Project	IEEE 802.16 Broadband Wireless Access Working Group < http://ieee802.org/16 >	
Title		
Date Submitted		
Source(s)	Tal Kaitz	Voice: +972-36456273 mailto: tal.kaitz@alvarion.com
	Vladimir Yanover	Voice: +972-36457834 Fax: +972-36456290 mailto: vladimir.yanover@alvarion.com
	Naftali Chayat	Voice: +972-36456801 mailto: naftali.chayat@alvarion.com
	All with Alvarion Ltd. 21 A Habarzel St. Ramat - Hahayal Tel - Aviv 69710	
Re:		
Abstract		
Purpose		
Notice	This document has been prepared to assist IEEE 802.16. It is offered as a basis for discussion and is not binding on the contributing individual (s) or organization(s). The material in this document is subject to change in form and content after further study. The contributor(s) reserve(s) the right to add, amend or withdraw material contained herein.	
Release	The contributor grants a free, irrevocable license to the IEEE to incorporate material contained in this contribution, and any modifications thereof, in the creation of an IEEE Standards publication; to copyright in the IEEE's name any IEEE Standards publication even though it may include portions of this contribution; and at the IEEE's sole discretion to permit others to

Figure 4 Proposed Mapping of DL bursts

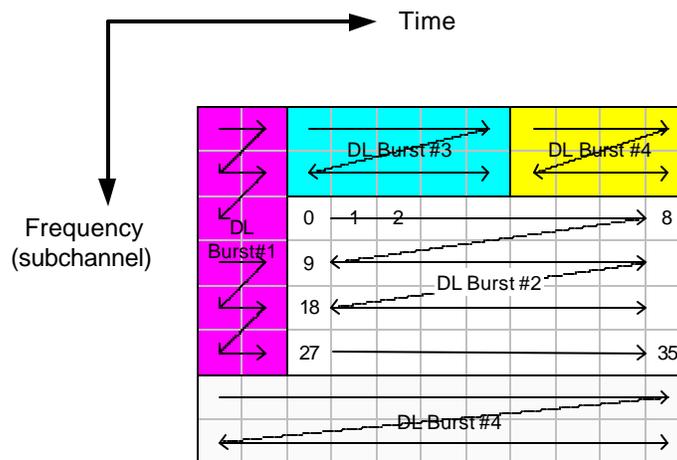
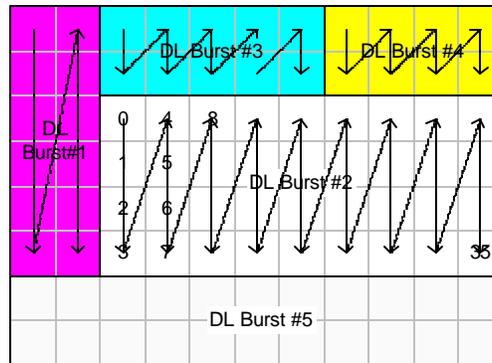
This scheme imposes significant buffering requirements. Bursts may span the entire duration of the sub-frame (In UL all bursts span the entire UL frame. In DL a burst may span the entire DL subframe). In both UL and DL a burst may span the entire bandwidth (i.e. the entire number of subchannels.)

In both cases the maximum buffer size needs to be equivalent to the entire subframe.

Burst buffering can be maintained in one of several stages within the encoding-decoding process. The most efficient buffering is performed by storing decoded data bits. In this case the buffer size is $20\text{msec} \times 71\text{Mb/s} = 1.42\text{Mbit}$. Memory requirements of this magnitude have a significant impact on the cost of the VLSI H/W.

In the DL it is proposed to change the mapping from time first to frequency first.

- 1) Segment the data into blocks sized to fit into one OFDMA slot.
- 2) Each slot shall span one or more subchannels in the subchannel axis and two OFDMA symbols in the time axis (see Figure 216). Map the slots such that the lowest numbered slot occupies the lowest numbered subchannel in the lowest numbered OFDMA symbol.
- 3) Continue the mapping such that the ~~OFDMA symbol index is increased~~ Subchannel index is increased. When ~~the last subchannel is reached~~ ~~edge of the Data Region is reached~~, continue the mapping from the lowest numbered ~~subchannel~~ ~~OFDMA symbol~~ in the next OFDMA symbol ~~subchannel~~.

Figure 5 Proposed Mapping of UL bursts

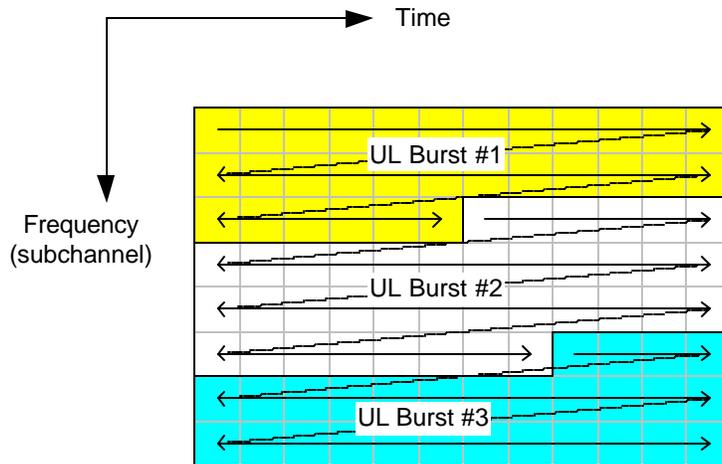
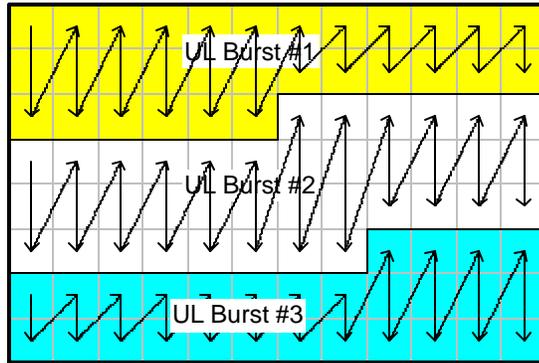
It is proposed to maintain the same uni-dimensional mapping structure as in figure Figure 2. However, within each allocated burst, the mapping order shall be frequency first. This is illustrated in Figure 5.

The UL mapping consists of two steps. In the first the OFDMA slots allocated to each burst are selected. In the second steps the allocated slots are mapped.

- 1) Map the slots such that the lowest numbered slot occupies the lowest numbered subchannel in the lowest numbered OFDMA symbol.
- 2) Continue the mapping such that the Subchannel index is increased. When the last subchannel is reached, continue the mapping from the lowest numbered subchannel in the next OFDMA symbol. The resulting order is shown in figure XXXX.

Figure 6 Example of FEC blocks in an UL burst

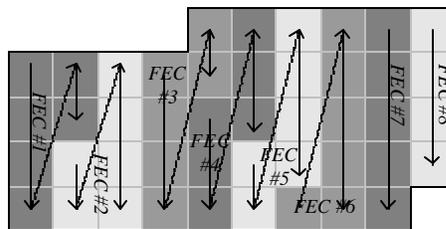
In the UL, a FEC block shall span s slots, where s is the number of subchannels per FEC block, as defined in 8.4.9.2.

Note that a FEC block may span more than one OFDMA slot epoch (a slot epoch is time duration of slot e.g. 3 OFDMA symbols in PUSC). A FEC block boundary may not coincide with a OFDMA slot epoch. This is illustrated in Figure 6, where a QPSK rate $\frac{1}{2}$ ($j=6$) allocation of 45 subchannel \times symbols is encoded using 6 FEC block with $s=6$; one FEC block with $s=5$; and one FEC block with $s=4$. This is according to the rules of 8.4.9.2.

n : For the DL, number of allocated subchannels. For the uplink, the number of slots in the allocation.

Figure 7 General structure of an UL burst

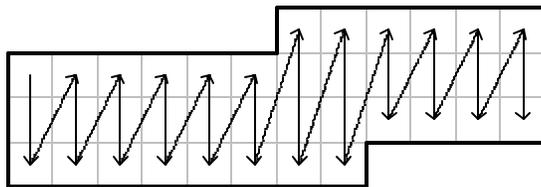
- 1) Segment the data into blocks sized to fit into one OFDMA slot.
- 2) Each slot shall span one or more subchannels in the subchannel axis and three OFDMA symbols in the time axis (see Figure 217). Order the slots such that the lowest numbered slot occupies the lowest numbered subchannel in the lowest numbered OFDMA symbol.
- 3) Continue the ordering such that the OFDMA symbol index is increased. When the edge of the UL zone (which is marked with Zone_switch_IE) is reached, continue the ordering from the lowest numbered OFDMA symbol in the next available subchannel. Thus an ordered list of slots is thus created.
- 4) An UL allocation is created by selecting an integer number of contiguous slots, according to the ordering of steps 1-3. This results in the general Burst structure shown in figure XXX
